ONSITE SEWAGE DISPOSAL SYSTEM

P 554540-13

PROPERTY ADDRESS: 13014 High Grove Road

SCHOOLEY MILL FARM
 SITE PLAN FOR BAT INSTALLATION FOR LOT 9
 13014 HIGHGROVE ROAD
 Zoned: RR-DEO
 Tax Map No. 40; Grid No. 10 & 11; Parcel No. 115 & 149
 Fifth Election District - Howard County, Maryland
 Date: April, 2014 Scale: As Shown

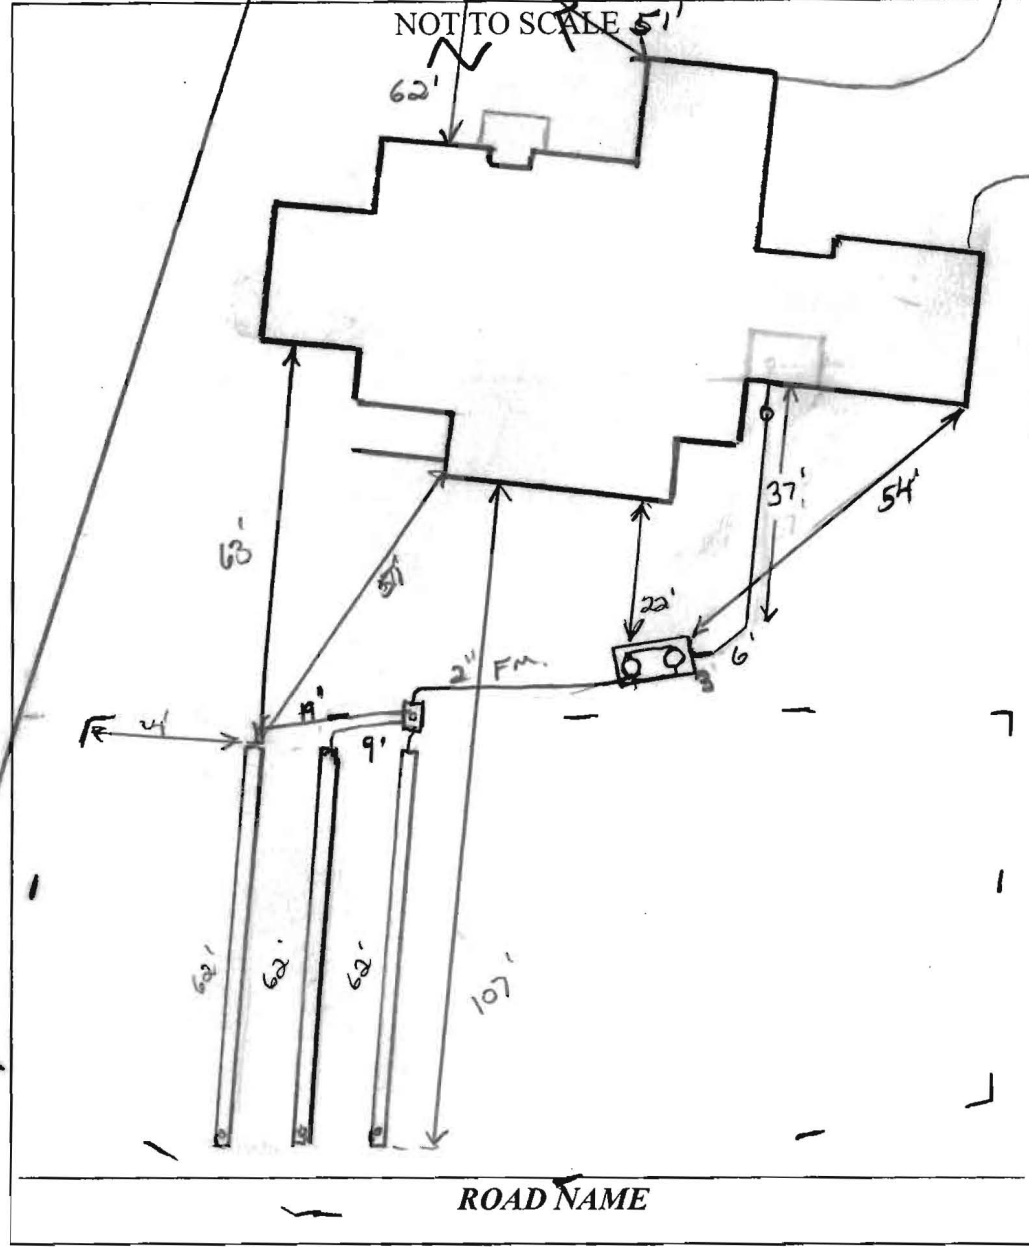
8/4/14 Contour very choppy. Could not find usable contour on high side of SPA. Utilize lower (left) side of SPA. set Dbox to part of septic area, run 3 x 62' trenches across septic area on contour as pointed out in field. set tank per stake out. (KW)

INSTALLATION: 8/7/14 BAT unit being set. No trenches started. (KW)
 8/13/14 Trenches complete. OK to come all work up to the point. (KW)
 8/14/14 Dist. box set. Plumbing installed to tanks. 2" F.M. run. SAC started. OK to confirm (KW)
 8/15/14 SAC complete. Need BAT start-up (KW)
 10/7/14 onsite w/ rep. BAT start-up successful. Rep needed to mount probe in new location. Need BAT start-up from manufacturer (KW) Start-up received. gw

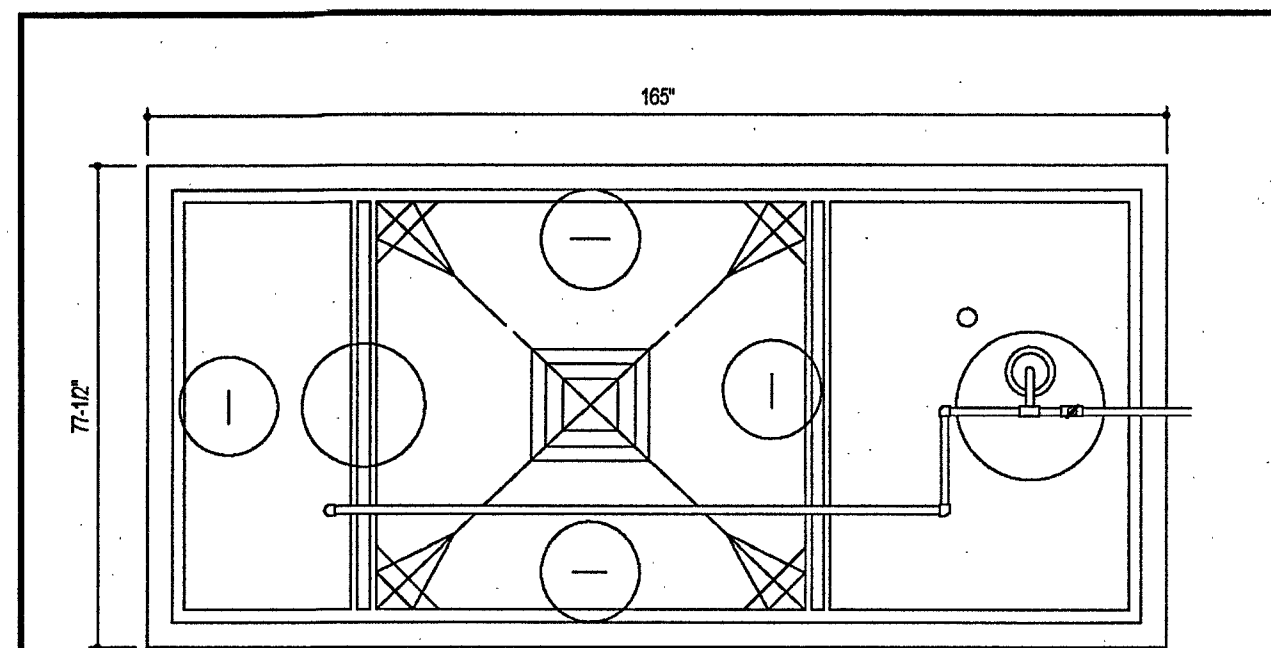
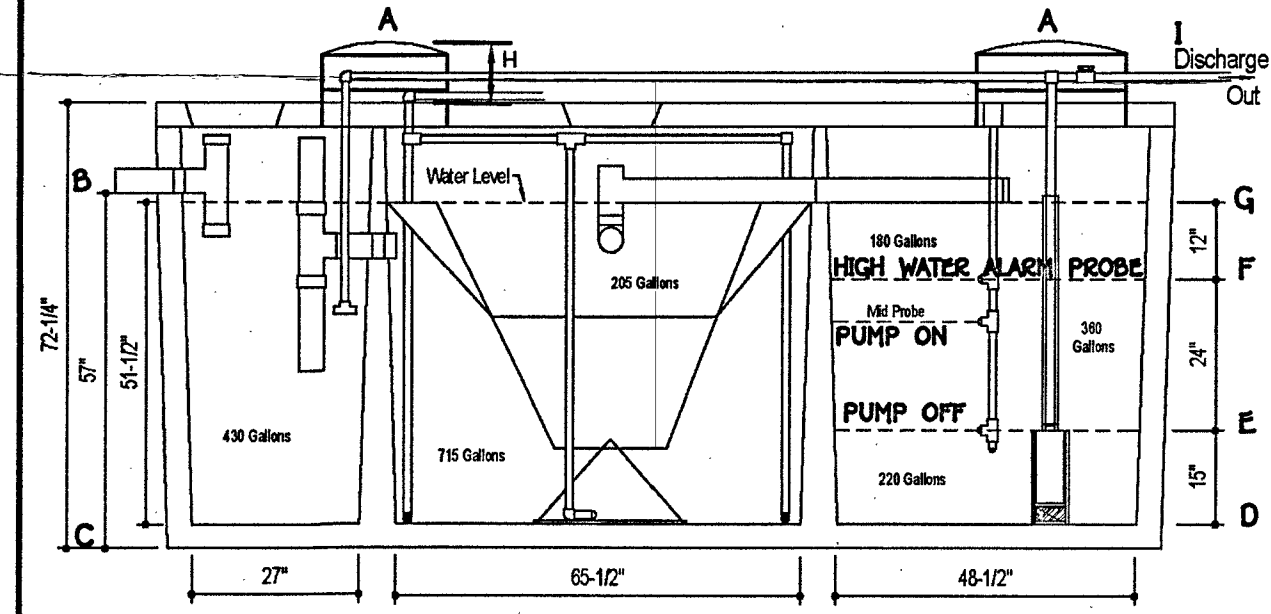
Attached are Roberts comments and spec sheets for lots 6 and 7. Additionally, as we discussed, we need a hydraulic profile on all of the plans. We also need to see the blower motor location on all the plans. And, we need to see the trench layout with elevations for the initial as well as the two reserve systems.
